To Council Mar 24, 2003
To Planning - Mar 18, 2003
Date: March 6, 2003 *File: 8060-20-7450*
RZ 02-213387 *File: 8060-20-7496*
File: 8060-20-7491

RE: APPLICATION BY PATRICK COTTER ARCHITECT INC. FOR REZONING AT 22111, 22171, 22191 WESTMINSTER HIGHWAY FROM AGRICULTURAL DISTRICT (AG1) TO COMPREHENSIVE DEVELOPMENT DISTRICT (CD/61), COACH HOUSE DISTRICT (R/9) AND SINGLE FAMILY HOUSING DISTRICT, SUBDIVISION AREA A (R1/A)

Staff Report

SUBDIVISION PLAN

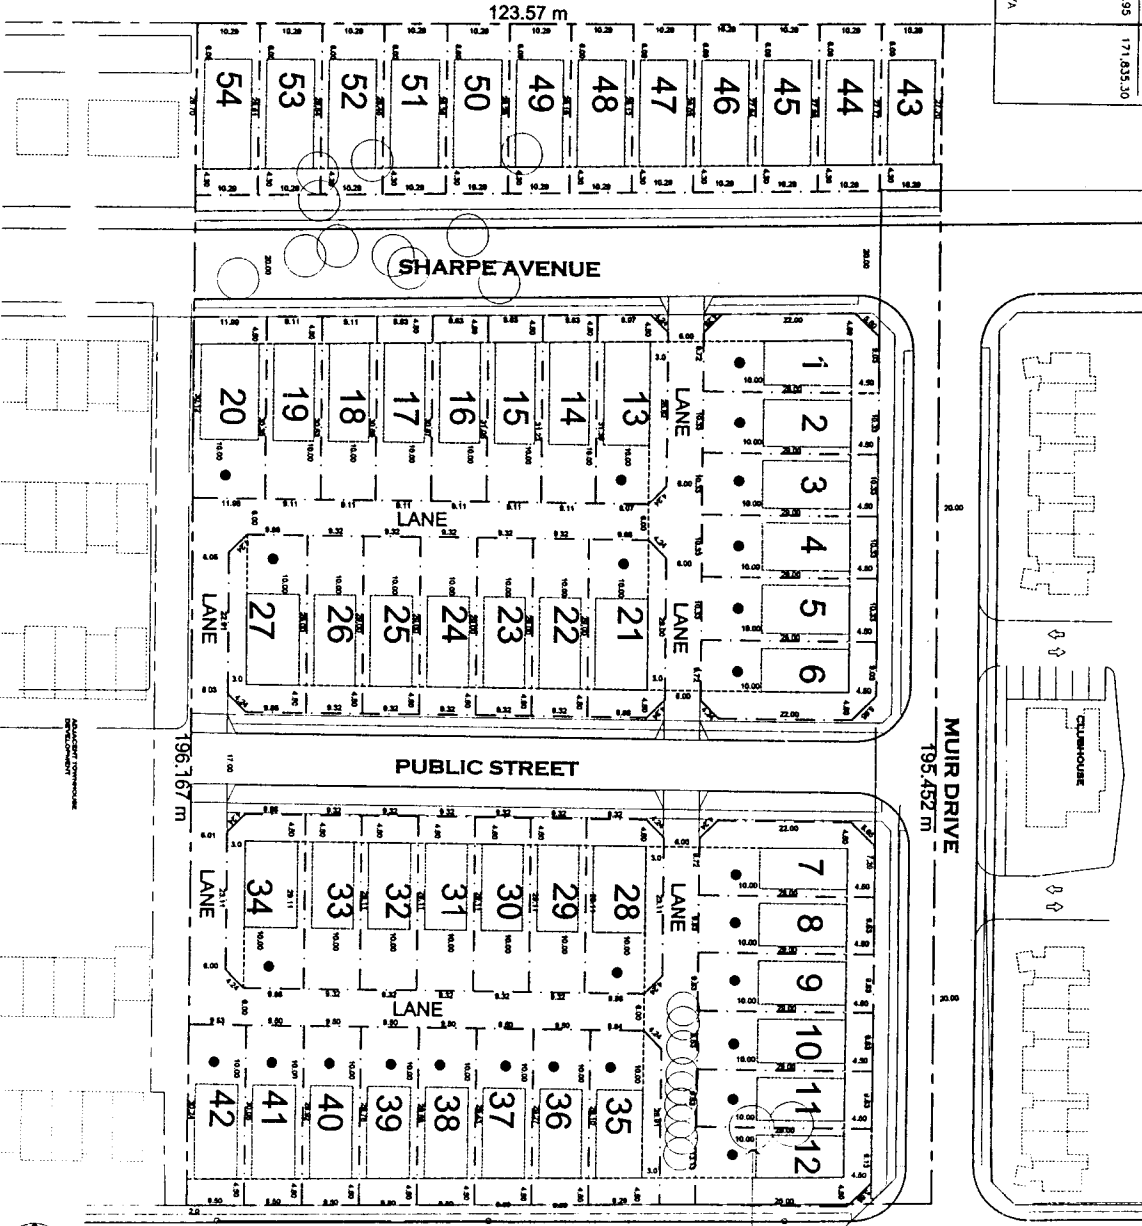
Attachment 2 shows the proposed subdivision layout and location of lots. Sharpe Avenue would be extended through the development site to connect to the sections that have already been built or dedicated as part of neighbouring development proposals. The west side of Muir Drive, which is now partially built, would also be completed. A new public road and lanes would be created to service the area south of Sharpe Avenue.

The twelve (12) R1/A lots are proposed to be located north of Sharpe Avenue, where there is insufficient lot depth to create a lane. These single-family lots would abut existing single-family lots in the subdivision immediately to the north.

The R/9 coach house lots are proposed to be located along Westminster Highway and Muir Drive and at several specific locations abutting a lane. The R/9 zone permits the construction of a principal dwelling on the lot as well as a second dwelling unit above a rear garage.

The remaining 16 lots south of Sharpe Avenue, all of which are located on internal roads, are proposed to be zoned CD/61. This zone permits a single-family dwelling unit with space (but not a dwelling unit) above a rear garage.
